ADDENDUM NO. 1
November 5, 2018

PROJECT: *Goff Street and Fulwood Park Improvements*

OWNER: City of Tifton

1. CONSTRUCTION DOCUMENTS/PLAN – SHEET C2.0

SHEET NO:
C2.0

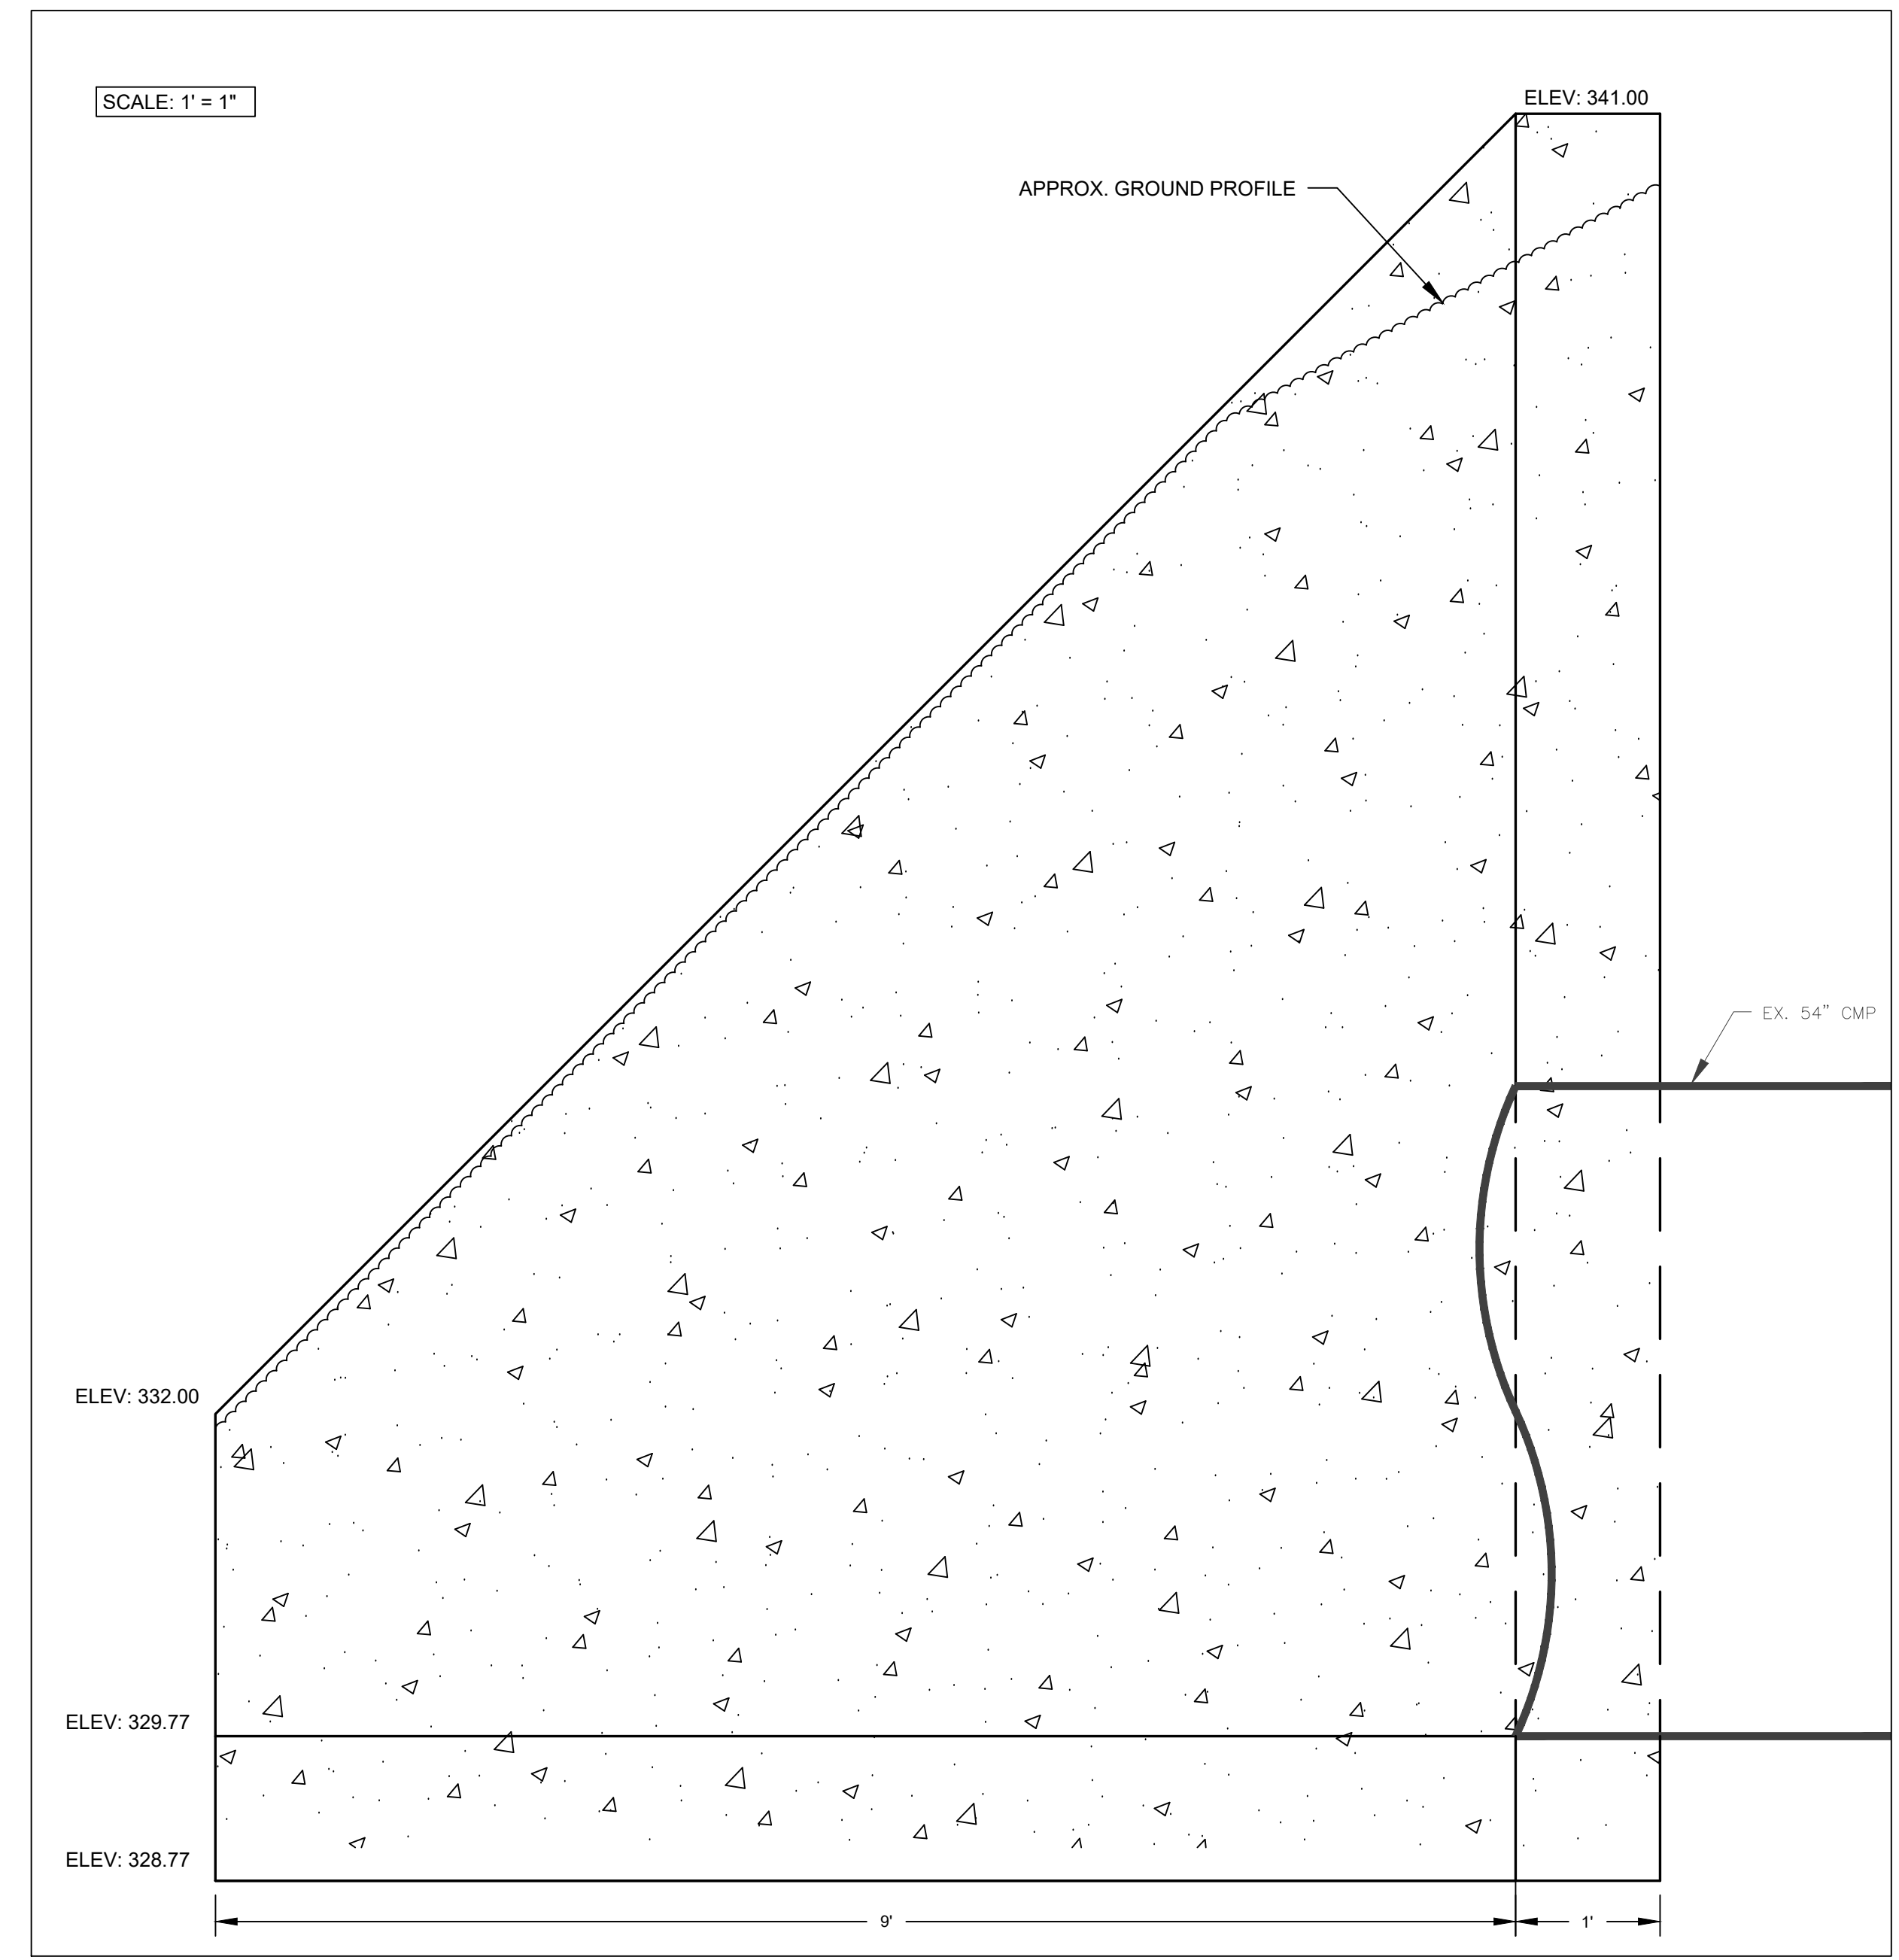
- a. The amount of proposed asphalt overlay has increased and is reflected in the plans and the BID FORM.
- b. The contractor shall mill the edge of existing pavement to ensure an even connection of the proposed asphalt overlay to the existing pavement. Payment for this item shall be included in the bid item for asphalt overlay.
- c. The proposed guardrail along the western side of Goff Street shall be constructed 5' off the edge of pavement.
